Licensee's Post Written Examination Comments and NRC Resolutions

Comments on Indian Point 2 July 2010 Initial NRC License Examination

Attached Graphs:

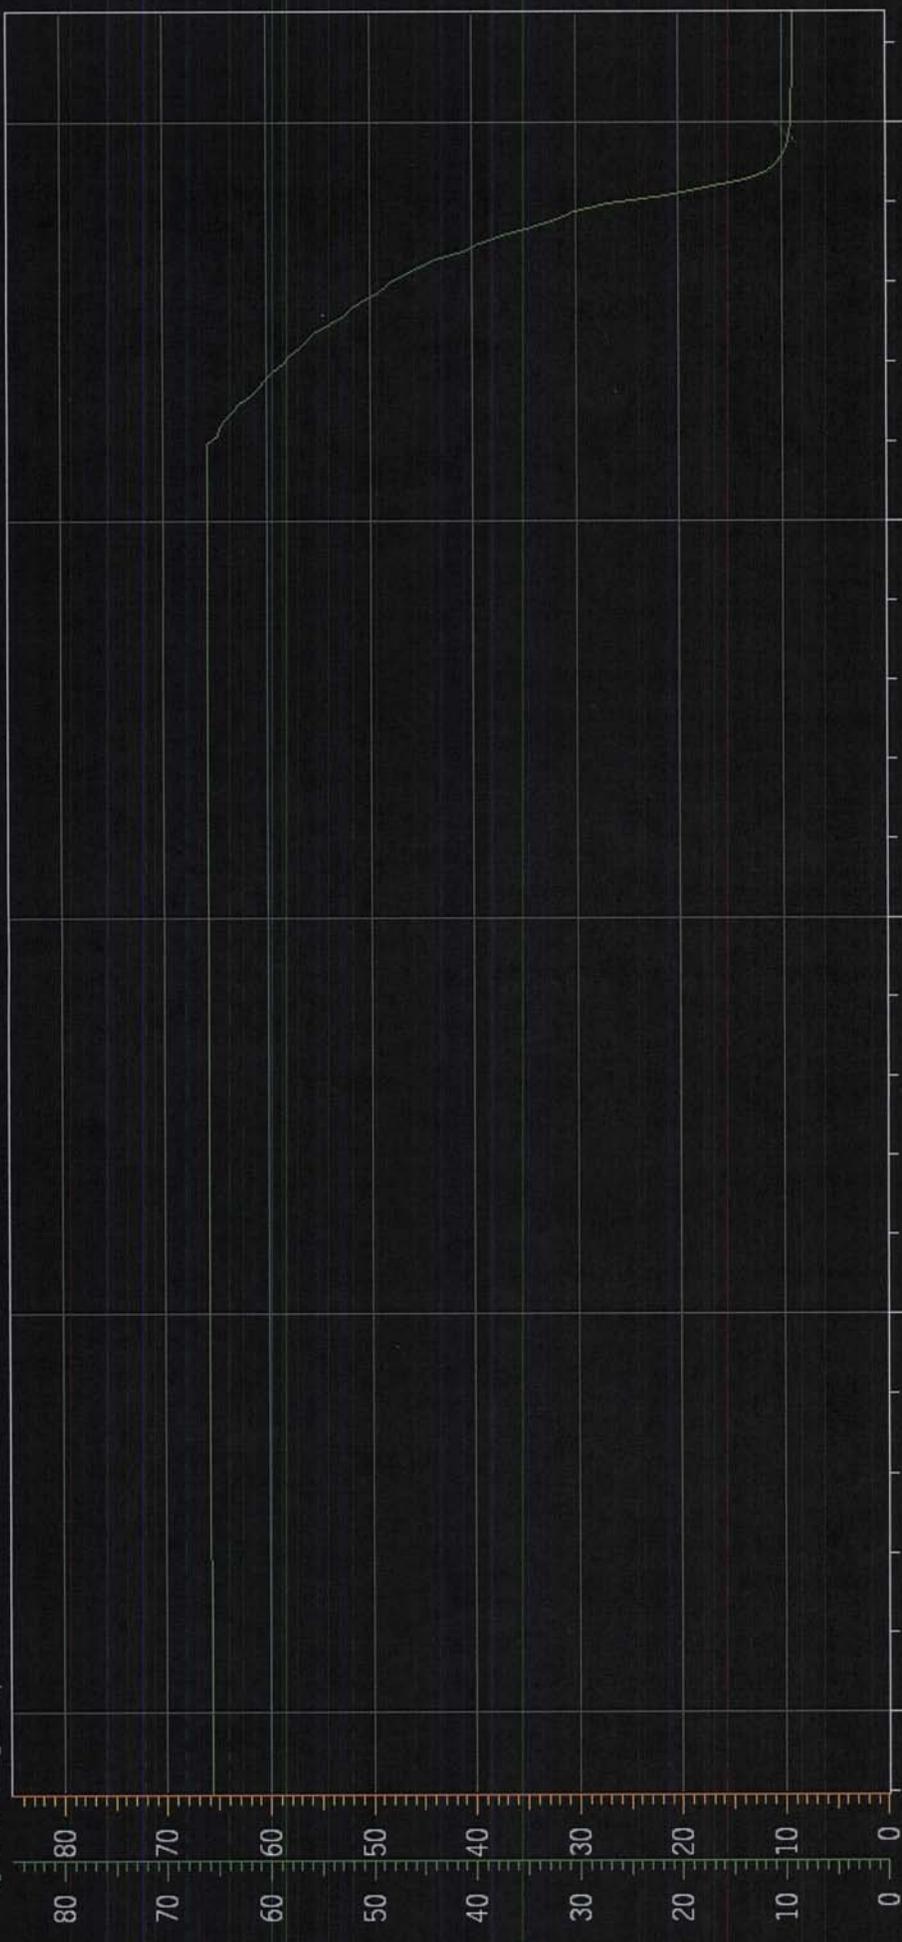
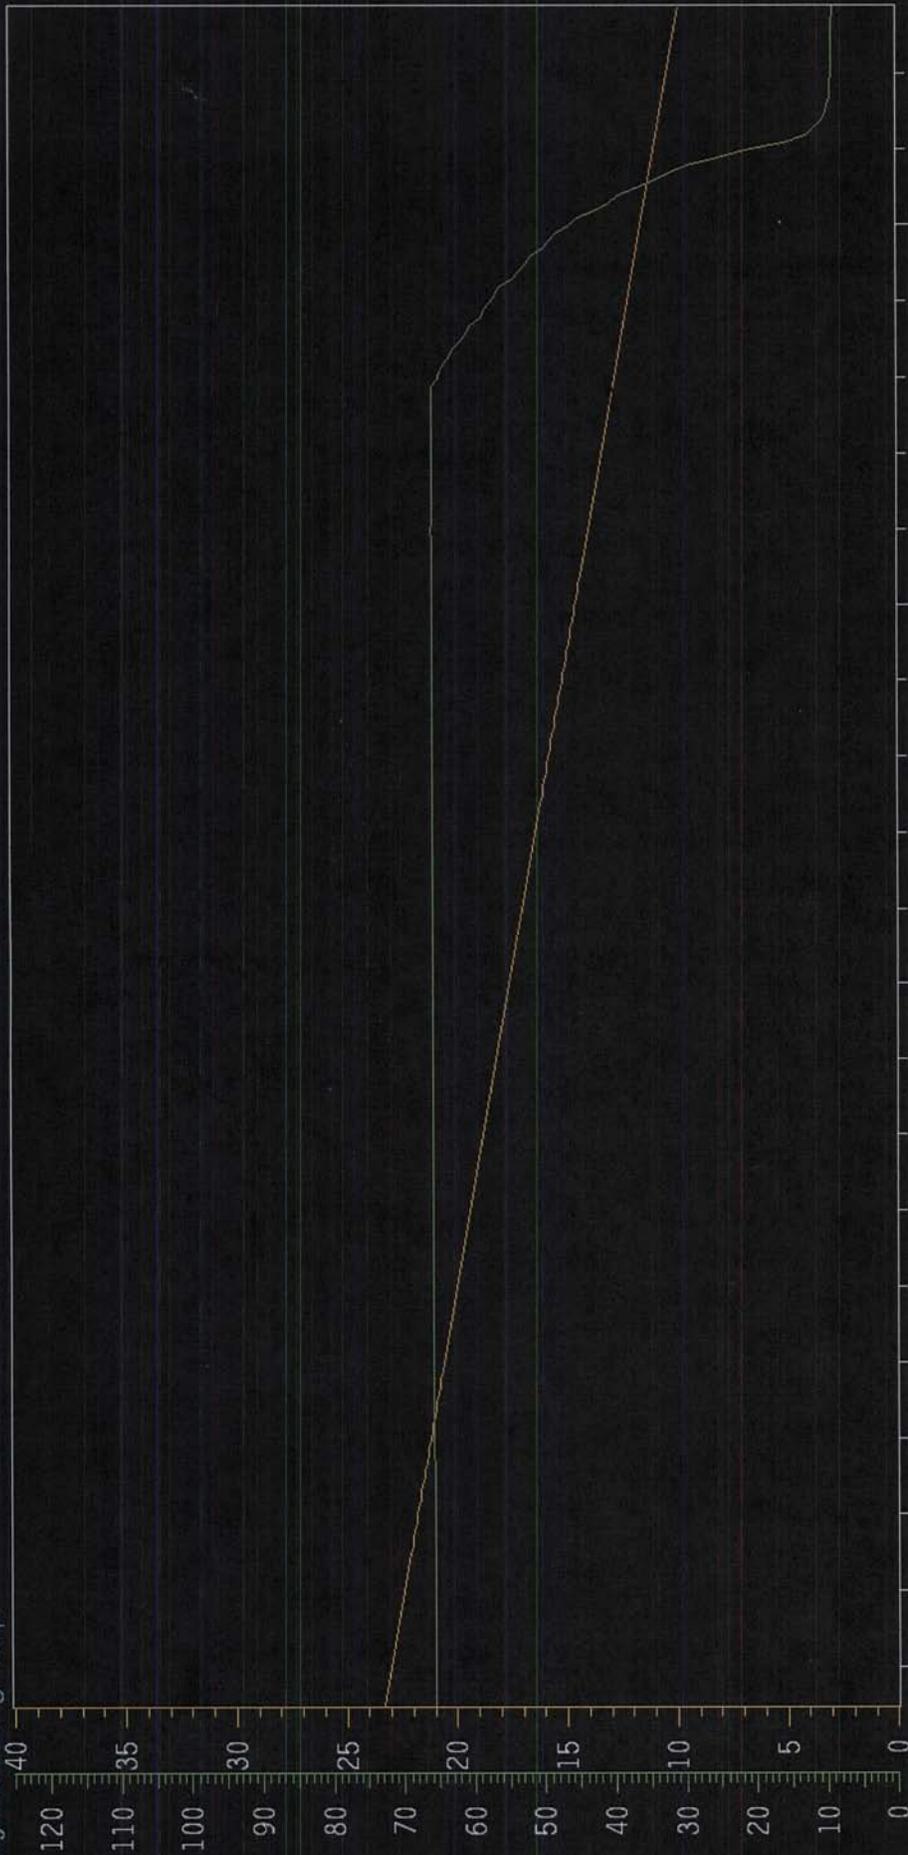
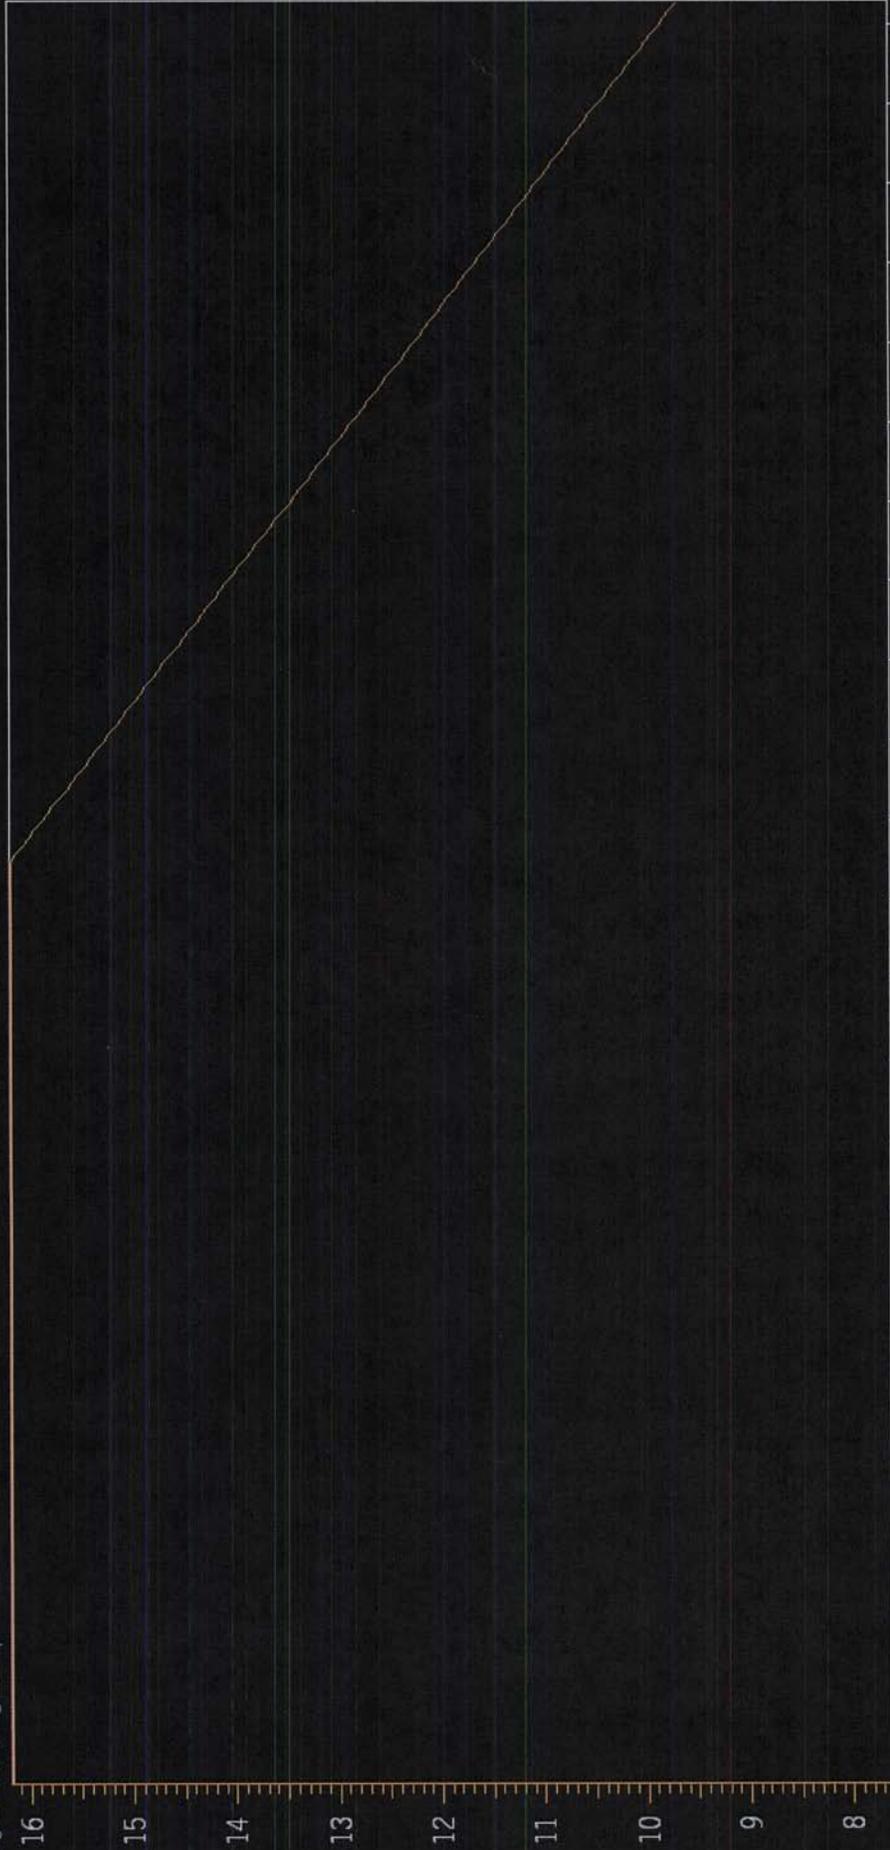
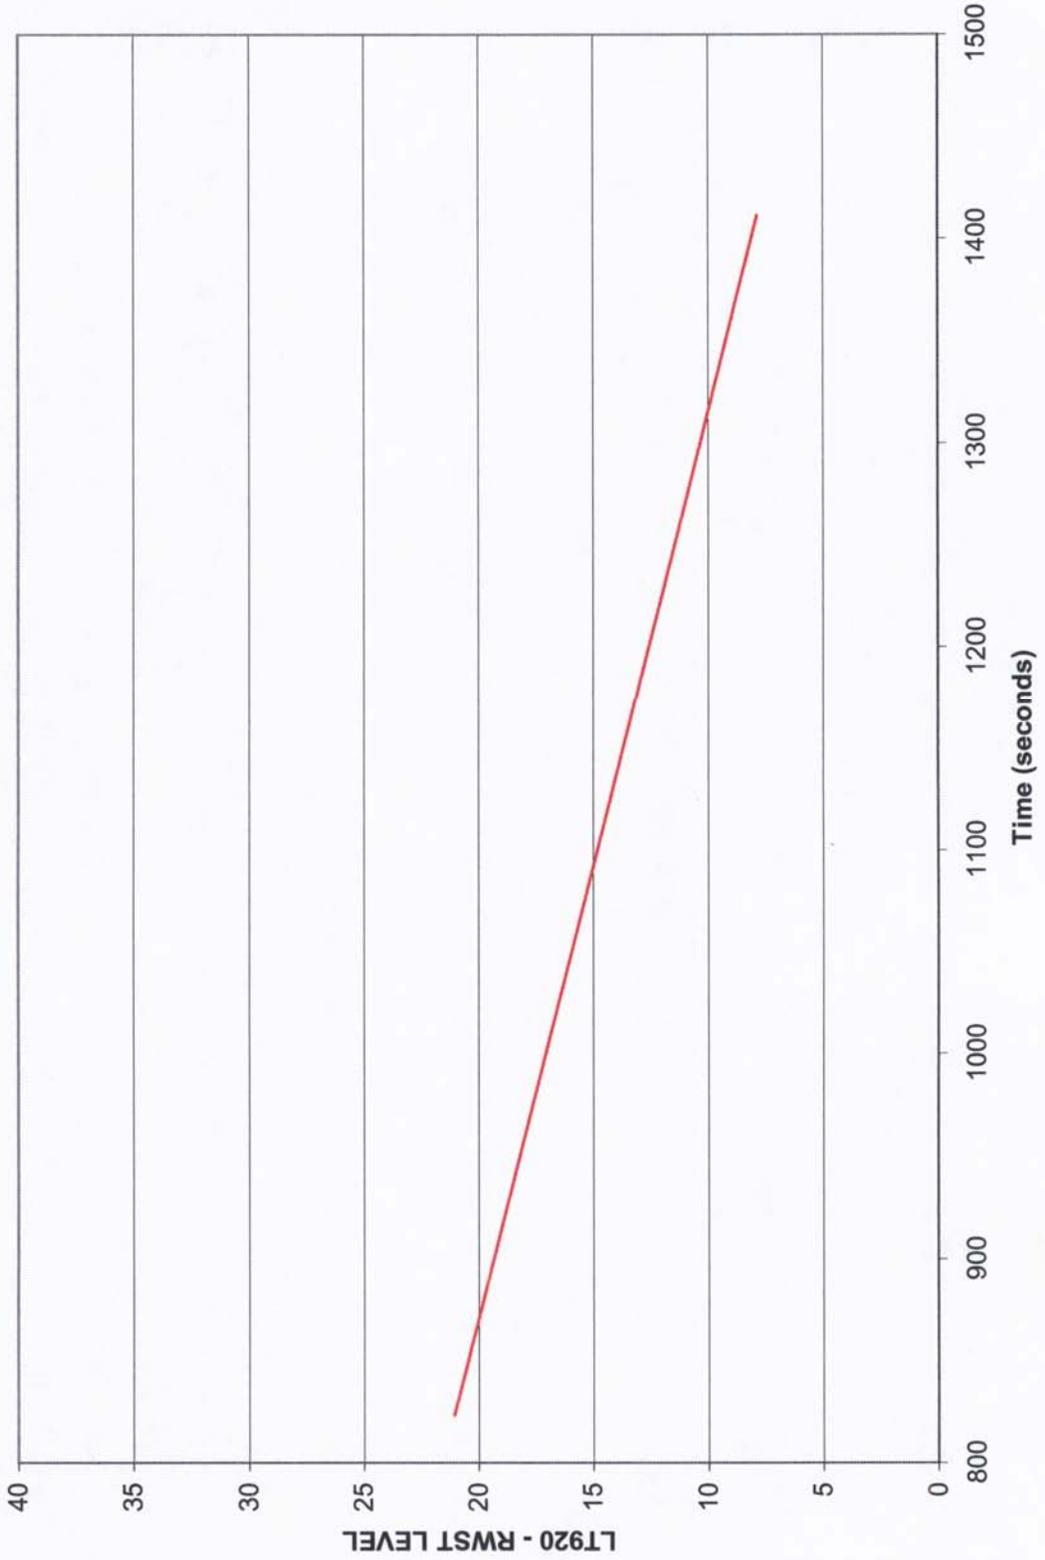
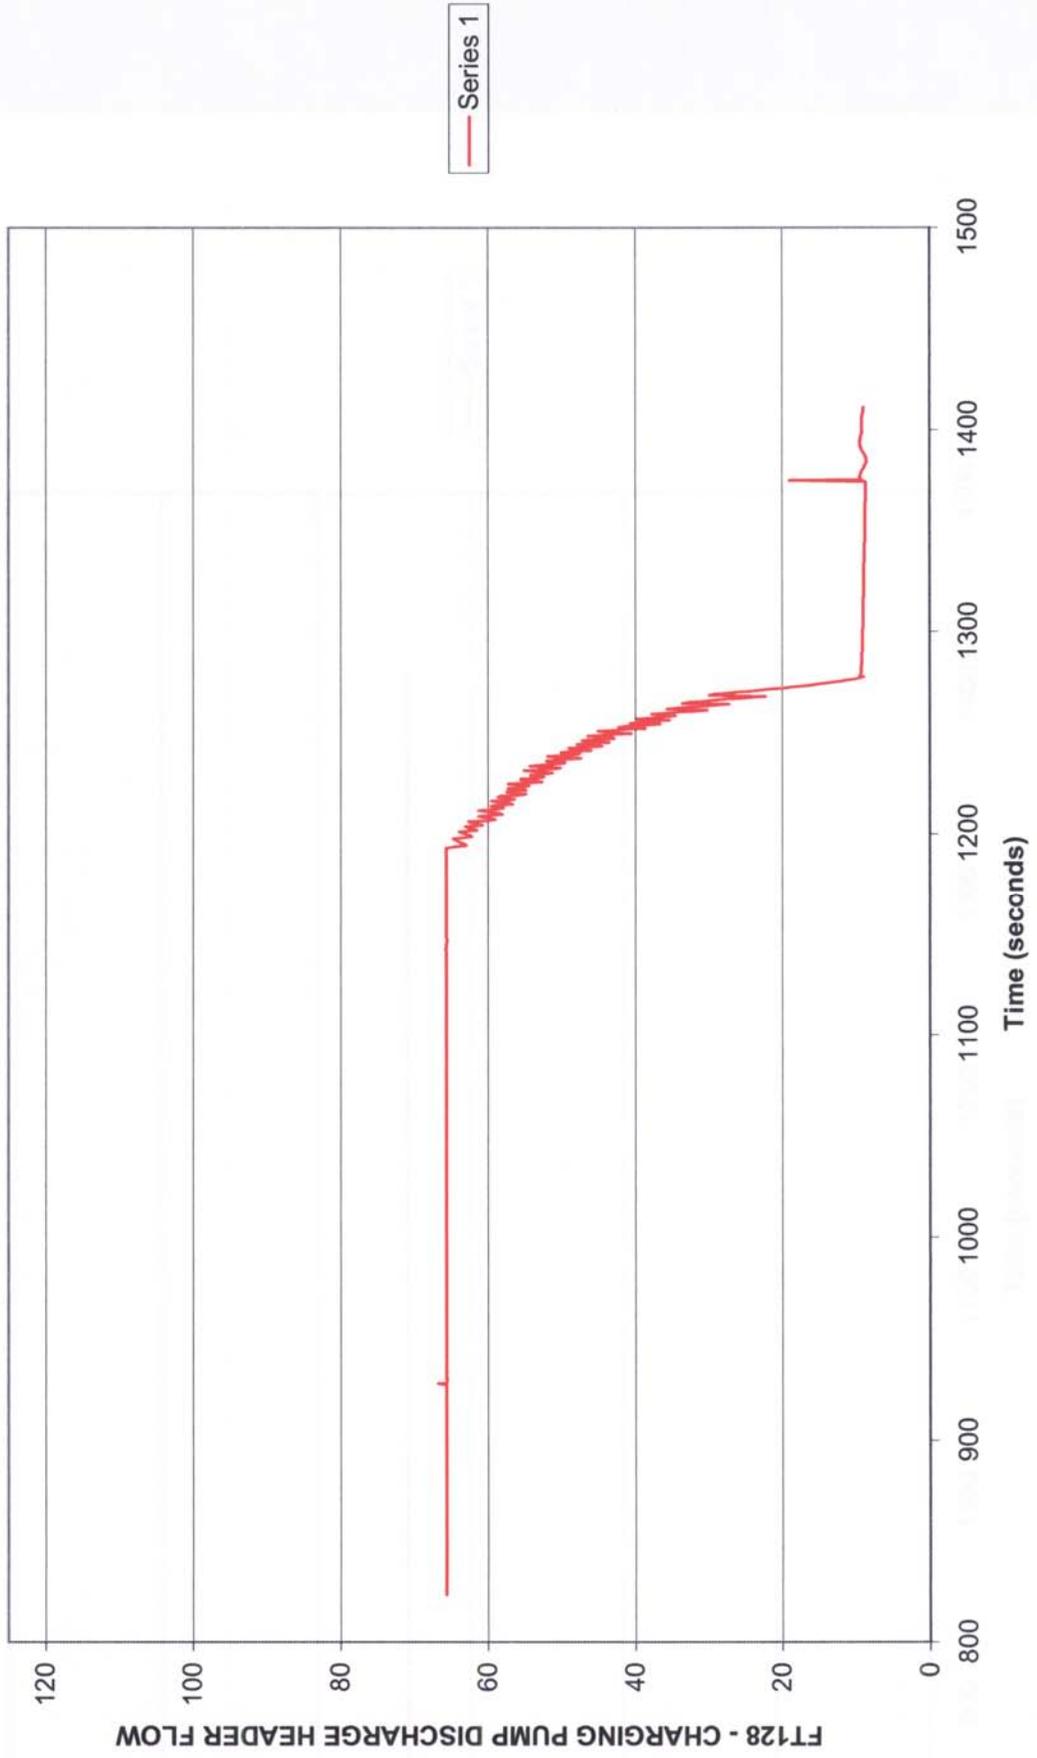
IPEC disagrees with the answer key that Answer B (22 Charging Pump prior to manipulating Recirc Switches in ES-1.3, Transfer to Cold Leg Recirculation) is the correct answer. Although the charging pump could be secured first, it would be secured in 2-E-1, prior to entering 2-ES-1.3 for the following reasons:

- Page 9 of 2-E-1 contains a CAUTION that states “If RWST level decreases to less than 15 ft. charging pumps that are started or running should be monitored for loss of suction which may result in pump damage.” In the IPEC Unit 2 Simulator the candidates have observed that charging flow begins decreasing when RWST level lowers to 12 ft, with charging flow significantly reduced by the time that RWST level reaches 11 ft. The operators have been trained to secure the charging pumps when they observe charging pump flow decreasing due to loss of suction. During initial charging pump operation starting in 2-E-0, the charging pump is placed in service at maximum speed with charging flow at approximately 65 gpm. Data taken during LBLOCA in the Unit 2 simulator supports that charging pump discharge flow drops significantly (see attached). When RWST level reaches approximately 12.7’, flow is observed to begin lowering with the charging pump still at maximum speed. At approximately 10’ in the RWST, flow has lowered to 9 gpm. Operators are trained to secure a piece of running equipment when its suction source is lost.

- Answer B does not correctly identify the procedural guidance for securing the charging pump. Although Step 4 of 2-ES-1.3 stops all charging pumps to reduce 480V bus loads, the charging pumps would already be secured in 2-E-1 when RWST level lowered to less than 12 ft but prior to transitioning to 2-ES-1.3 at 9.24 ft.

The NRC position is that "B" answer would always be a correct answer based on the procedural guidance alone: 1) The procedural guidance in 2-E-1, Page 9, CAUTION that states "If RWST level decreases to less than 15 ft. charging pumps that are started or running should be monitored for loss of suction which may result in pump damage." However, this guidance does not provide explicit direction to secure the charging pump(s) based on this caution and in some cases it may be desirable to maintain the pump(s) running as long as possible; 2) In contrast, 2-ES-1.3 does provide explicit guidance on when the charging pumps must be secured. The CAUTION just prior to step 4 states, "Any pumps taking suction from RWST should be stopped if RWST level decreases to 3.0 ft for SI and charging pumps....";

3) 2-ES-1.3, step 4, provides further direction to stop all charging pumps and this is done prior to performing procedural step 6, "Place Safety Injection Recirc Switches 1 AND 3 to ON" that provides the bases for selecting answer choices "C" or "D". The question stem asks which of the following pumps could be secured first, answer choice "B" states, "22 Charging Pump prior to manipulating Recirc Switches in ES-1.3, Transfer to Cold Leg Recirculation". The licensee has provided justification for stating charging pumps may be secured earlier using the guidance in 2-E-1. Given a LBLOCA condition, the charging pumps will always be secured first in the sequence whether using the guidance in 2-E-1 or by using the guidance contained in 2-ES-1.3. Finally, if for any reason the charging pumps are not secured prior to entering procedure 2-ES-1.3 then this procedure directs that the charging pump(s) would be secured prior to taking the action in procedure step 6 that provides the basis for selecting answer choice "C" or "D". The NRC disagrees that key answer B is incorrect.

The question stem asks the candidates to determine two things: 1) which pumps could be secured first, and 2) what is the procedural guidance for this action [securing the pumps]? The NRC concludes that answer "C" (22 SI Pump from Recirc Switch 1 in ES-1.3, Transfer to Cold Leg Recirculation) should also be accepted as a correct answer for the following reasons: 1) The procedural guidance in 2-E-1, Page 9, CAUTION states "If RWST level decreases to less than 15 ft. charging pumps that are started or running should be monitored for loss of suction which may result in pump damage." In addition, the 2-E-1 Background document, page 56, basis section indicates that a section of the charging pump suction piping is at an elevation of 15 feet above the bottom of the Refueling Water Storage Tank (RWST). If RWST level decreases to less than 15 feet a vacuum will be drawn in that section of the piping that may cause a decrease or loss of charging pump suction pressure and flow; 2) The operators have been trained to secure the charging pumps when they observe charging pump flow decreasing significantly due to loss of suction in order to protect plant equipment; and 3) The Unit 2 simulator data provided by the licensee for Large Break Loss of Coolant Accident (LBLOCA) indicates that charging pump discharge flow drops significantly when RWST level lowered to less than 12 feet. 4) Transitioning to 2-ES-1.3 is not done until level in the RWST level decreases to less than 9.24 ft. Therefore, based on guidance in 2-E-1, the simulator data and training provided to the operators, it is conceivable that the operators would be expected to secure any running charging pumps prior to transitioning to procedure 2-ES1.3 (i.e., especially since all other systems are operating normally as the stem of the question indicates. It follows then that if charging pumps are secured earlier in 2-E-1 for all of the reasons stated above (i.e., prior to transitioning to 2-ES1.3) then 22 SI pump could be the first pump secured in 2-ES-1.3.

The NRC has determined that in both cases noted above the applicant could transition to 2-ES-1.3 by appropriately using the station procedures and cautions. The result is that the charging pumps could be on or off depending upon the use of the caution step in 2-E-1, prior to entering 2-ES-1.3, which could lead to either answer B or C being correct.
